ADDRESSEES	: Owners and operators of vehicles mentioned under “Application” ABC Customer Care and Parts Source
VEHICLE TYPE	: CX45 MY2023
CONFIGURATION GROUP	: 2.46 Traction engine – Accessory drive
BULLETIN TYPE	: Field change program
DATE	: October 16th, 2023
SUBJECT	: Inspection of automatic belt tensioner base plate fasteners
CONDITIONS	: Refer to chapter "Warranty" further on in this bulletin.

Figure 1: Location of the fasteners securing the automatic belt tensioner base plate

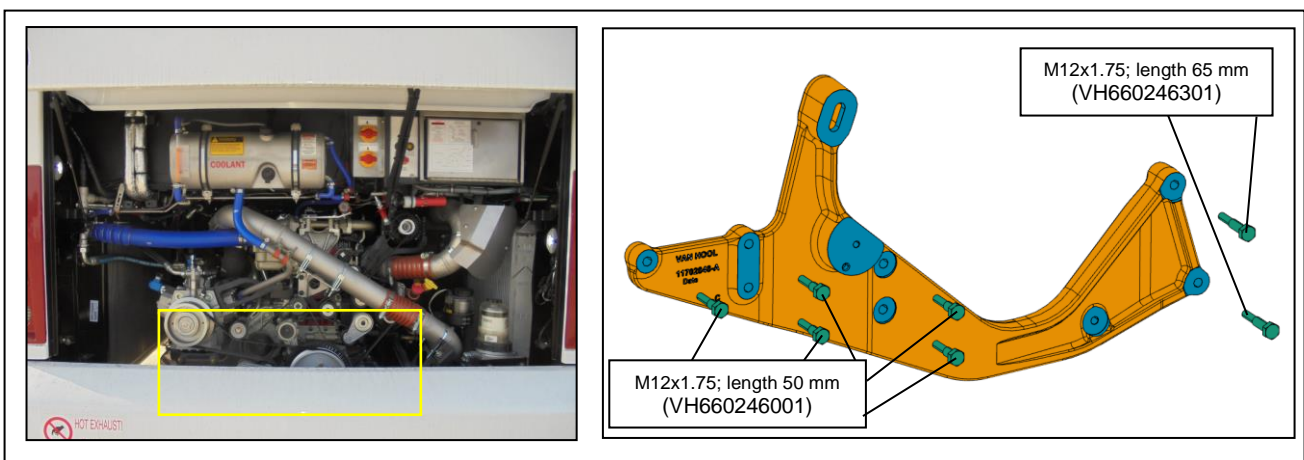
Van Hool has determined that some of the seven fasteners securing the automatic belt tensioner base plate are subject to slackening. Tests have shown that these fasteners must be installed with Loctite 243 and tightened to a torque of 90 ± 10 Nm (65 ± 7 ft.lbf).

To address this issue, Van Hool is conducting a field change program whereby the seven fasteners must be removed and checked one by one for length and thread pitch (1.75 mm). What to do next is explained in this service bulletin.

Step	Action
1	Open the engine compartment rear access door.
2	Remove one of the seven affected fasteners (refer to figure 1).
3	Identify the length and thread pitch of the fastener (refer to figure 1). <ul style="list-style-type: none">• If length and thread pitch are okay: clean the thread of the fastener removed. Apply Loctite 243 on the thread and re-install the fastener with a torque of 90 ± 10 Nm (65 ± 7 ft.lbf).• If the thread pitch is okay, but the length is not: take a fastener with the proper length. Clean the thread of the fastener. Apply Loctite 243 on the thread and install the fastener with a torque of 90 ± 10 Nm (65 ± 7 ft.lbf).• If the length is okay, but the thread pitch is not: temporary re-install the 1.5 mm thread pitch fastener with a torque of 90 ± 10 Nm (65 ± 7 ft.lbf) and contact ABC to determine the next step.
4	Repeat steps 2 and 3 for the six other affected fasteners.
